INSPECTOR'S REPORT ON AN APPLICATION FOR A CERTIFICATE OF AUTHORISATION FOR A CLOSED LANDFILL

TO:	DIRECTORS
FROM:	Brian Meaney - Environmental Licensing Programme
DATE:	25 September 2017
RE:	Application for a Certificate of Authorisation from Cork County Council for a closed landfill at Kealanine Certificate of Authorisation Register Number H0089-01 .

Figure 3 Conceptual site model

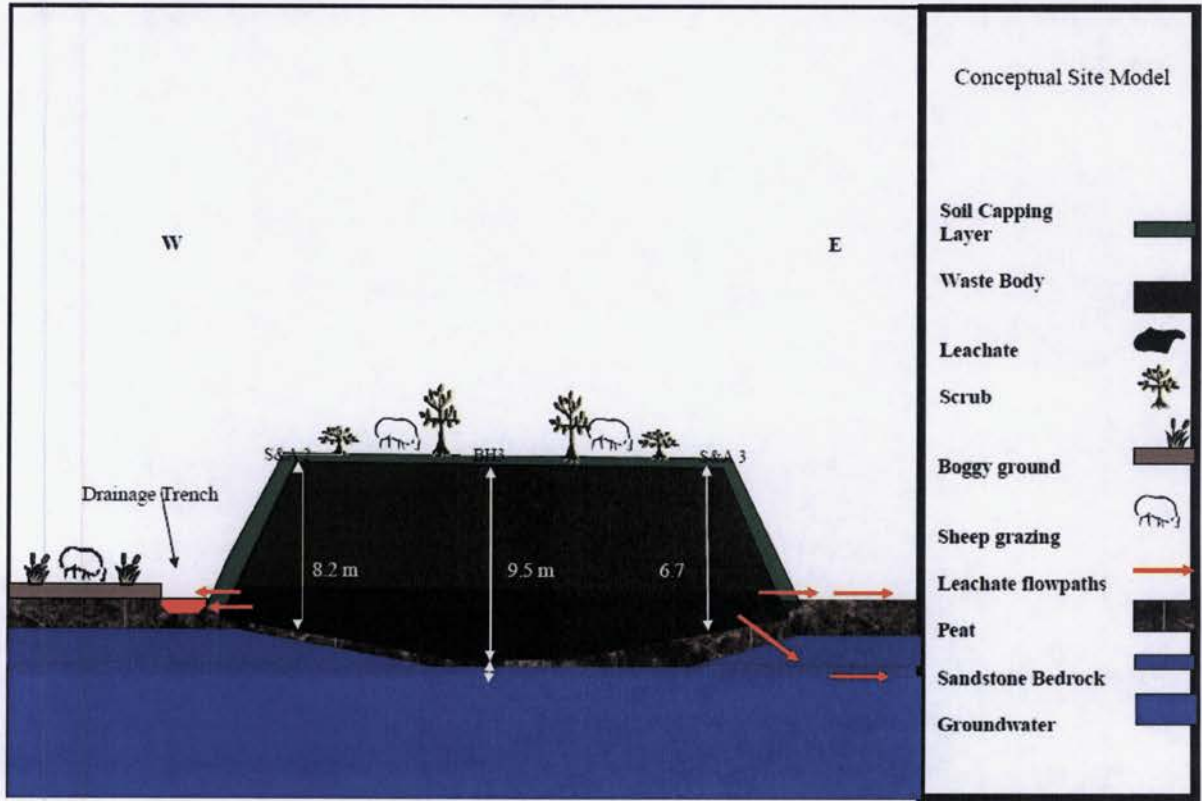
Landfill gas:	<p>An elevated concentration of methane was found at one location in 2011. At 20% v/v, this is greater than the upper explosive limit of 5% v/v. Three other locations measured from zero to 2.1% v/v.</p> <p>Further monitoring in 2014 showed significantly elevated concentrations (10-43% v/v) at 4 locations, indicating that landfill gas continues to be generated in significant quantities.</p> <p>There are no potential receptors within 400m of the site.</p>
Conceptual site model:	<p>The conceptual site model is shown in Figure 3.</p>

<p><u>Source:</u></p> <p>Rainfall on the landfill will preferentially percolate through the cap and into the waste.</p> <p>Leachate is generated in the waste albeit at low strength.</p> <p>Gas is generated at the landfill, primarily localised in the area of hydrocarbon disposal.</p> <p><u>Pathway:</u></p> <p>Leachate can migrate through the base of the landfill into peat, sand and gravel and bedrock layers beneath.</p> <p>Surface seeps of leachate discharge to local drainage ditches.</p> <p>Dominant flow pattern for groundwater is to discharge within a short distance to surface water.</p> <p>Gas migration can occur through the permeable cap and in the sand and gravel deposits and fractured bedrock beneath the waste.</p> <p><u>Receptors:</u></p> <p>All houses are served by private wells. There are three located between 400m and 1,000m of the landfill.</p> <p>The bedrock aquifer has low potential for groundwater resources development.</p> <p>Leachate discharges directly or via groundwater to a local stream which flows to the Coomhola River. The local stream is the dominant receptor for waterborne contamination. Water quality improves to background levels prior to its confluence with the Coomhola River.</p> <p>There are no receptors for gas migration.</p>
